RE: Tentative Tract Map No. 74500-CN
Related Case No.: N/A
Address(s): 1553 S. Armacost Ave
Planning Area: West Los Angeles
Zone : R3-1
D. M. : 126B145
C. D. : 11
CEQA : ENV-2017-13-CE

In accordance with provisions of Los Angeles Municipal Code (LAMC) Sections 17.03, the Advisory Agency approved Tentative Tract Map No. 74500-CN, located at **1553 South Armacost Avenue** for the subdivision of one lot with a maximum of **eight (8) condominium units** as shown on map stamp-dated January 4, 2017 in the West Los Angeles Community Plan. This unit density is based on the RD1.5 Zone. (The subdivider is hereby advised that the LAMC may not permit this maximum approved density. Therefore, verification should be obtained from the Department of Building and Safety for legal interpretation of the Zoning Code as it applies to this particular property.) For an appointment with the Development Services Center call (213) 482-7077, (818) 374-5050, or (310)231-2598. The Advisory Agency's approval is subject to the following conditions:

TENTATIVE TRACT MAP NO. 74500

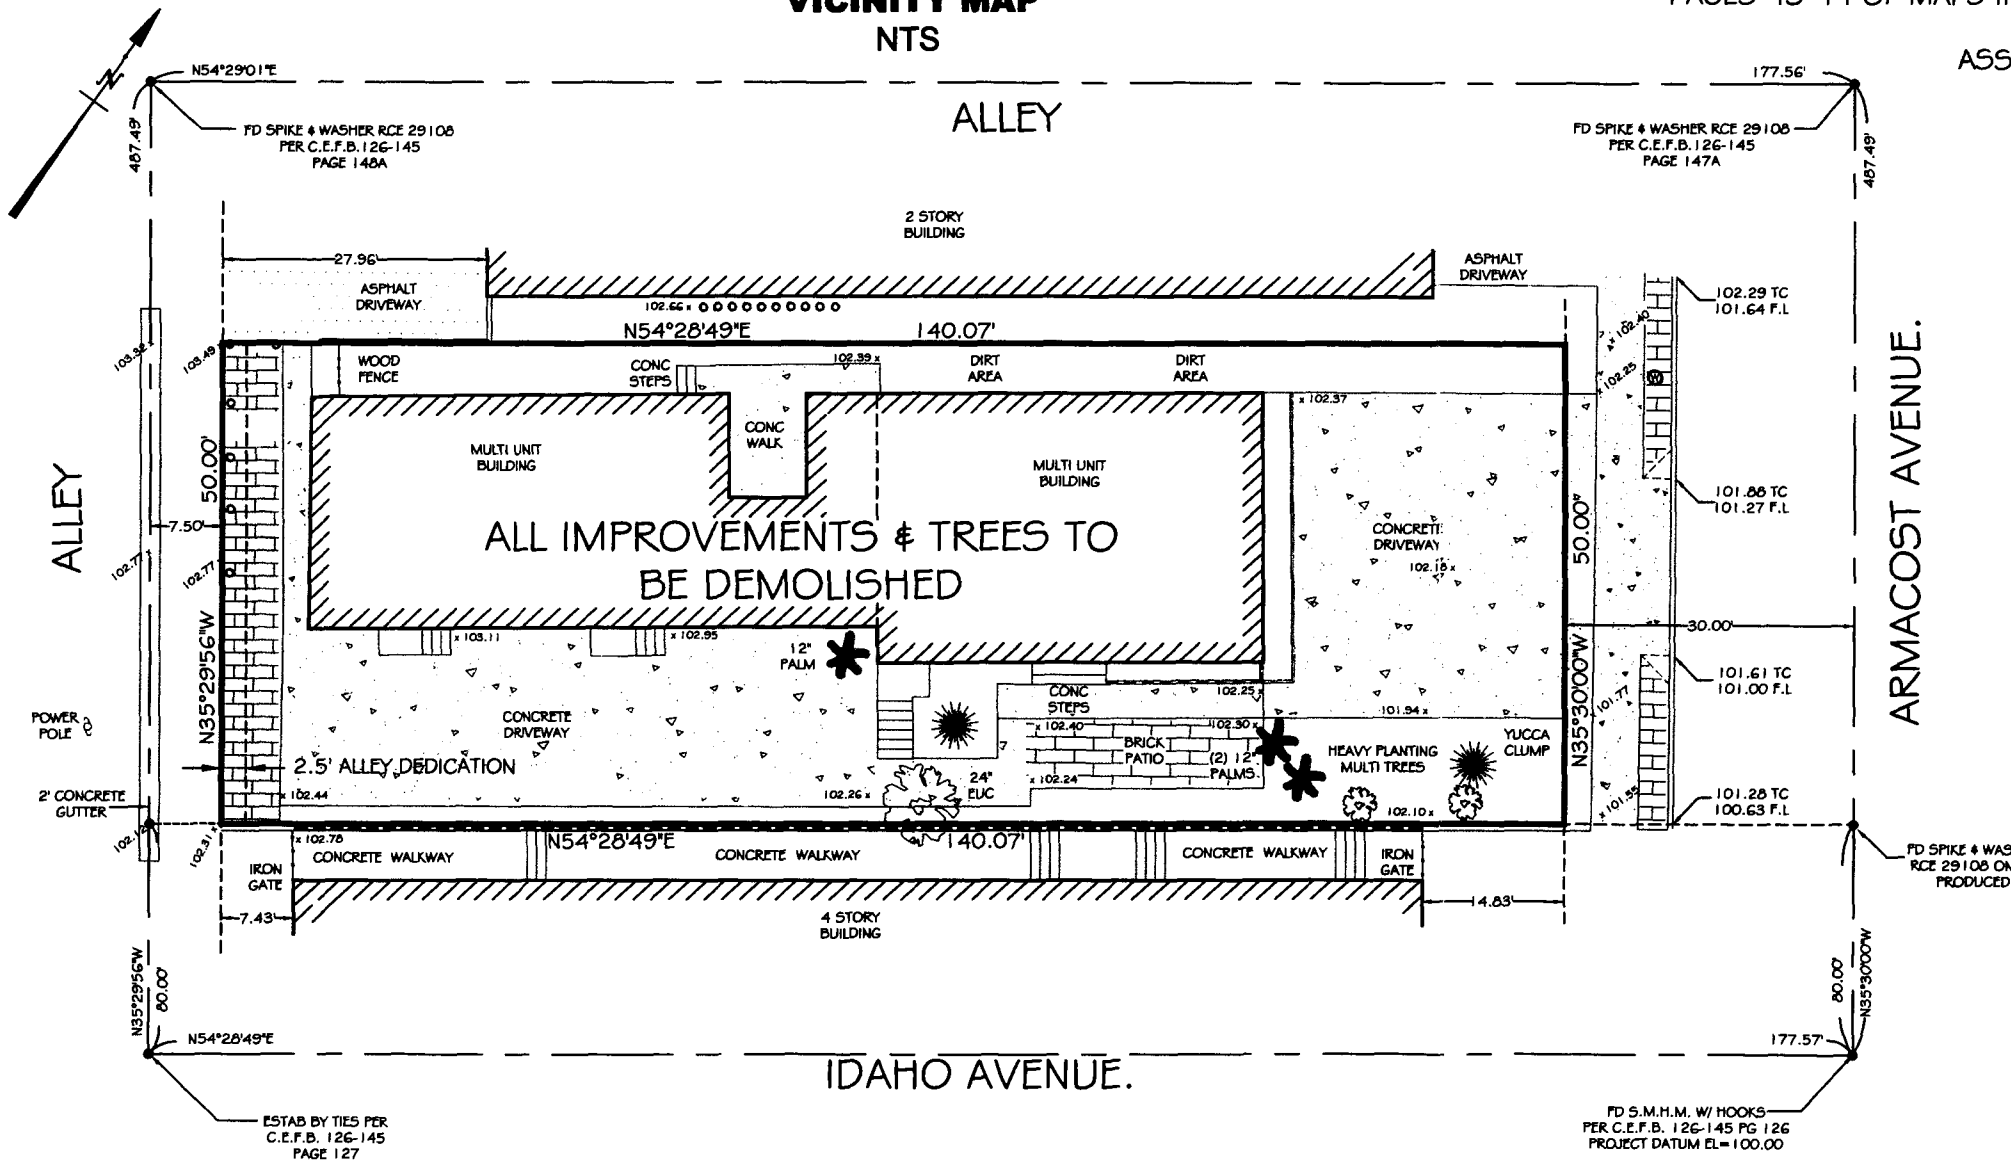
1. That a 2.5-foot wide strip of land be dedicated along the alley adjoining the tract to complete a 10-foot wide half alley.
2. That any fee deficit under Work Order No. EXT00737 expediting this project be paid.

4. Prior to recordation of the final map, the Department of Building and Safety, Zoning Division shall certify that no Building or Zoning Code violations exist on the subject site. In addition, the following items shall be satisfied:
 - a. Obtain permits for the demolition or removal of all existing structures on the site. Accessory structures and uses are not permitted to remain on lots without a main structure or use. Provide copies of the demolition permits and signed inspection cards to show completion of the demolition work.
 - b. Show all street/alley dedication(s) as required by Bureau of Engineering and provide net lot area after all dedication. "Area" requirements shall be re-checked as per net lot area after street/alley dedication.

- a. A minimum 20-foot reservoir space is required between any security gate or parking space and the property line, to the satisfaction of DOT.
- b. Parking stalls shall be designed so that a vehicle is not required to back into or out of any public street or sidewalk.
- c. This project is subject to the West Los Angeles Transportation Improvement and Mitigation Specific Plan requirements. A parking area and driveway plan shall be submitted to the Department of Transportation for approval prior to submittal of building permit plans by the Department of Building and Safety. Final DOT approval should be accomplished by submitting detailed site/driveway plans at a scale of 1"=40' to DOT's West LA/Coastal Development Review Section located at 7166 W. Manchester Ave., Los Angeles, 90045. Please contact 213-485-1062 for an appointment.

- a. Submittal of plot plans for Fire Department review and approval prior to recordation of Tract Map Action.
 - b. Access for Fire Department apparatus and personnel to and into all structures shall be required.
